Unionville SPA 2D Modelling Study and Floodplain Mapping Update

Toronto and Region Conservation Authority

TRCA Correspondence, Meeting Minutes

Steering Committee Meeting #1 Unionville SPA 2D Study and Floodplain Mapping Update TRCA

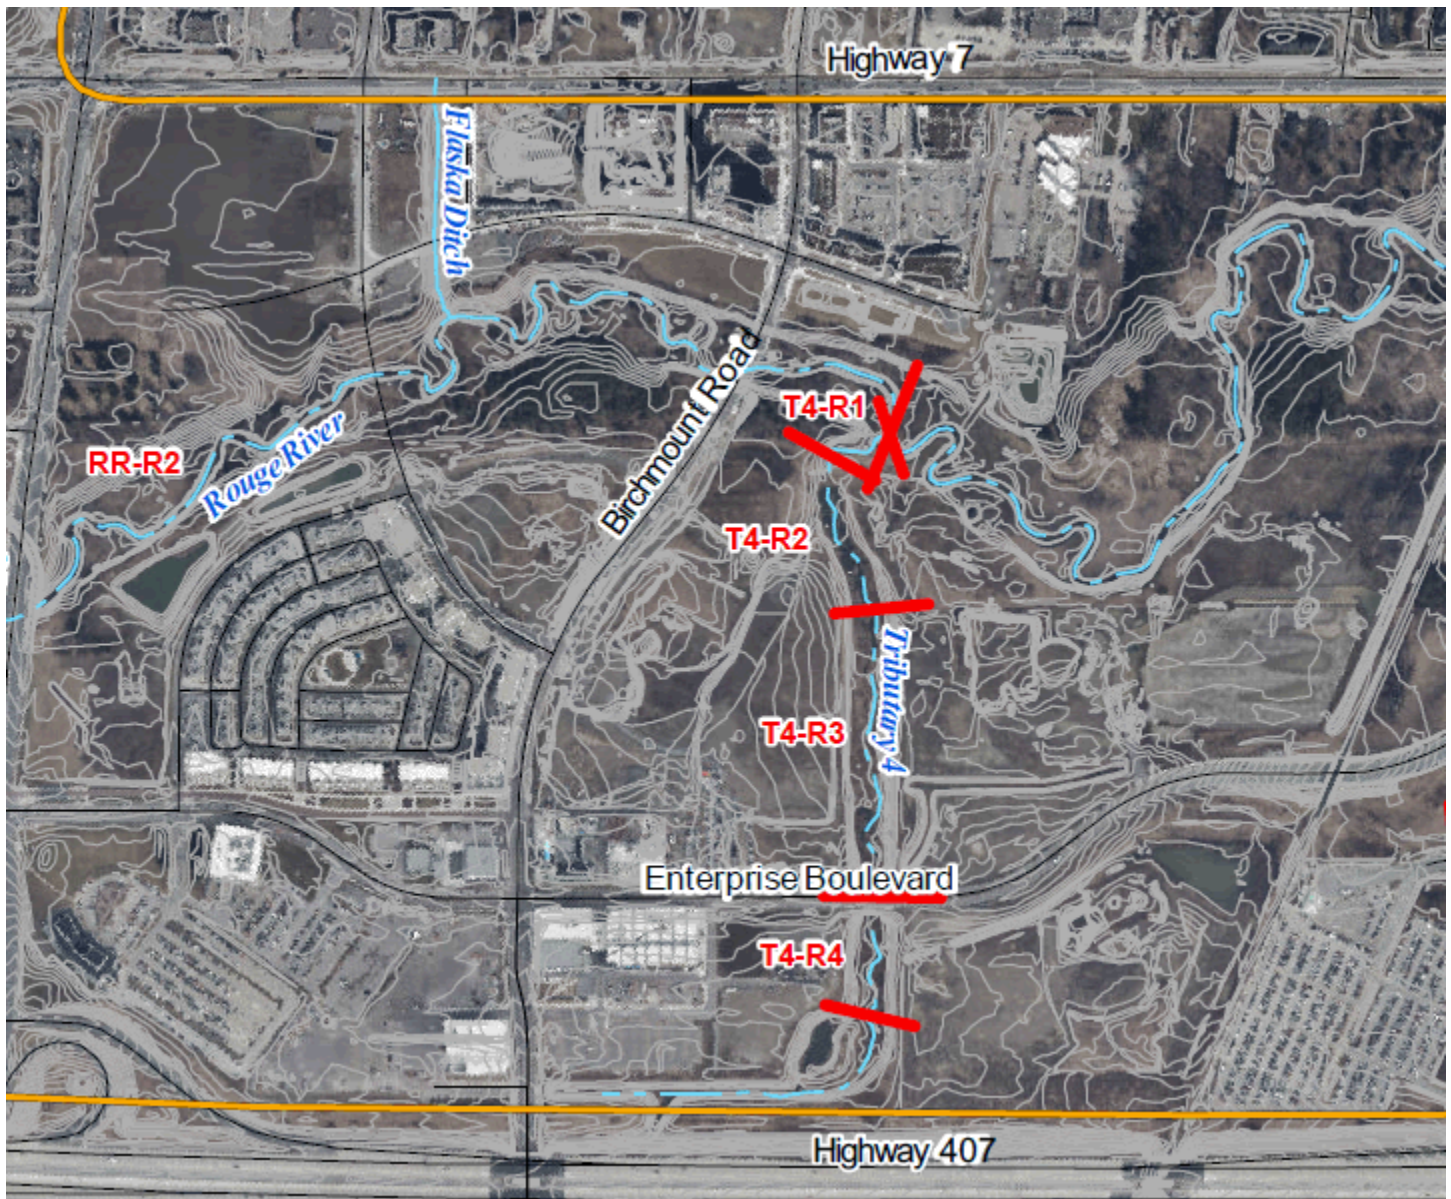
I have one thing that I like to have your big favour. As we talked today over the phone, the tributary running through Pan Am Center is actually starting from south of HWY 407. I know we are not going to model reach south of HWY 407 which is out of scope of work, but we still need account for the flow draining into that reach from south of HWY 407. In the attached image below, you will see a drainage area upto YMCA Blvd. delineated based on the 2015 Lidar data, and this drainage area is much bigger than what the 2018 Rouge Hydrology model used. I know your team is out in the field to verify crossings. Would it possible for your team to go to south of HWY 407? The purpose is to confirm if there is a ditch running through the highlighted area (black line) and if there is an outlet draining into this ditch.

Yes, we did look around this area when out in the field on Friday. There does appear to be a channel that runs as noted in blue on the map from Kennedy Road west towards the culvert under HWY 407. There is no evidence, however, of any outlets at the terminus of the noted channel at Kennedy Road. The drainage area indicated on the figure that you provided does look reasonable based on our approx. field observations. The high point to the south of HWY 407 appears to be around 14th Avenue. The railroad acts as a dam and it appears that major flow to the south of the railroad would be collected and conveyed to the Kennedy Road underpass and then be conveyed north on Kennedy Road towards the low point (near the noted channel) on Kennedy Road south of HWY 407. I don't know for sure, but I'm guessing that the storm sewer under Kennedy Road may run north under the recently constructed HWY 407 and 407 overpass and outlet minor flows to the watercourse somewhere on the north side of HWY 407. Major flow that would collect at the low point on Kennedy Road south of HWY 407 may end up spilling to the channel that runs from Kennedy Road west to the culvert under HWY 407. Lands to the east of Kennedy Road and north of the railroad appear to drain north and east to another culvert under HWY 407 to the east. Hope this helps!

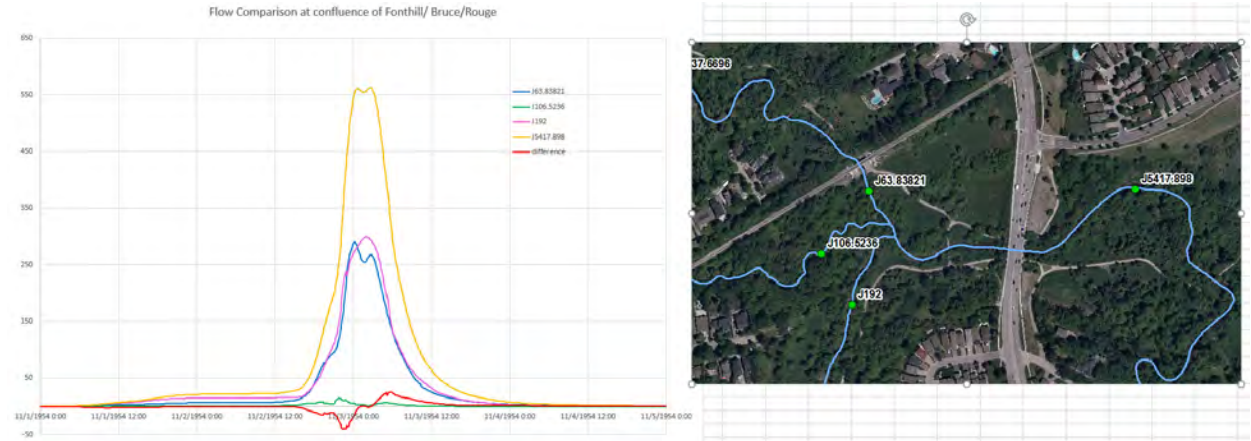
For example, the following plot shows the comparison of flows near confluence of Fonthill/Bruce/Rouge. In order to calculate the incremental flow from confluence to Node J5417.898, we sum hydrographs at Nodes J63.83821, J106.5236, J192, and then subtract hydrograph at Node J5417.898 from the total hydrograph at confluence. The red line in the plot shows the incremental hydrograph, you can see there are negative flows, and now the question is for steady state run which peak flow we should use, the biggest negative flow or positive flow? This situation occurs at other nodes as well. My thought is simply subtracting hydrographs between nodes to get incremental hydrograph still does not fully make sense in this case.

The way that we would typically approach this (and I believe was the original plan in this case) is to prepare the incremental hydrographs for the identified flow node locations based on the approved hydrology model using a similar approach as would be used for a HEC-RAS model (i.e. same approach regarding hydrograph timing and areal reduction would apply to the flows used). Not sure why you would be experiencing these discrepancies if the incremental hydrographs are prepared on this basis. The areal reduction factor would normally be accounted for in the hydrology model and so would not typically be an issue or cause for discrepancy. Having said that, however, I'm not aware of how exactly the areal reduction factor was applied to the hydrology model in this particular case. Without looking at this in depth, it's difficult for us to confirm all the details that have gone into the incremental flow preparations and why they are not matching with the hydrology model. If the TRCA has determined that a reduction in the flow is justified, we would recommend this be applied to the incremental hydrographs prior to including in the MIKE Flood model as opposed to applying a negative flow in the MIKE Flood model. Our concern is that this could lead to other potential issues (e.g. how will this be applied for unsteady model runs?) and it becomes awkward to explain this manipulation of the flow data within the MIKE Flood model. Hope this helps. Thank you.

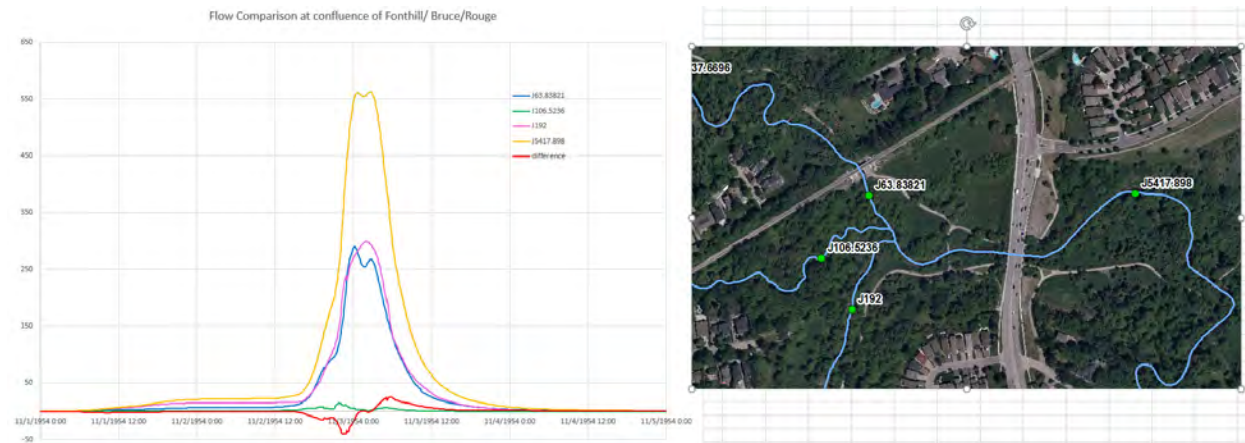
Since SPA is our main focus, and it is basically lying on area of the confluence of Fonthill/Bruce/Main Rouge, I think it would be appropriate to pull all flows (including total flows and lateral flows) upto Kennedy Rd at Node J5417.898 from the storm with 95.4% ARF applied at this node in hydrology model, and then pull rest of flows between Kennedy RD and Millie Dam from the storm with 94.8% ARF applied at the Dam in hydrology model. This is related to the application of the ARF and making equivalent adjustments for which we do not have all the detailed information to really comment. In principle, if the justification is there, it may be reasonable. We should also be thinking of the other storms we need to run such as 350-yr, 100-yr, 50-yr, etc. as we may also have similar issues to address. If adjusting the ARF is part of the process, it would of course only apply to the Regional storm. If so, we may want to think of an approach that could be applied for all storms. Please also see comments to next item.

For steady peaks, we pull total flow hydrograph at the flow nodes along the reaches, and find the peaks and subtract peaks from previous node to get increment peak, if the increment peak is negative then we donot apply any increment flow. The main issue contributing to the discrepancy in peak flows at similar flow node locations in MIKE Flood and in VO for this project appears to be attributed to the difference in timing and is most notable downstream of a confluence points. If the difference between peak flows downstream of a confluence point is greater than the additional contributing incremental flows to the downstream node, then the additional incremental flow alone based on the suggested approach may be too small to make up the difference. Perhaps another way to address this is to subtract the difference in peak flow from the upstream incremental hydrographs. For example, if the peak flow downstream of a confluence is 700 cms in VO and 800 cms based on the addition of peak flows upstream of the subject flow node in MF then 100 cms could be subtracted from the input flow hydrographs used in MF for the contributing branches/catchments upstream. The subtraction of flow from the upstream hydrographs could be distributed based on an area-weighted approach. If this were completed moving in a downstream direction at the flow nodes adjusting for differences in peak flow between the upstream sum total in MF and the peak flow from the VO model, then the flows should match pretty well between the MF model and the VO model. You may want to look into this approach in more detail to confirm it is acceptable.

For unsteady, we pull total flow hydrographs at the beginning of the reach, and pull lateral hydrographs. Since we are pulling flows from the same storm using ARF of 95.4% upto Kennedy RD, theoretically the unsteady simulation from MFlood should produce very similar hydrograph at Kennedy RD as that from hydrology model. We should still expect to see difference. **We would suggest that there should not be any issue in using the incremental unsteady flow hydrographs from the VO model in this case. The MIKE Flood model will handle the incremental unsteady flow hydrographs appropriately accounting for any differences in timing.**
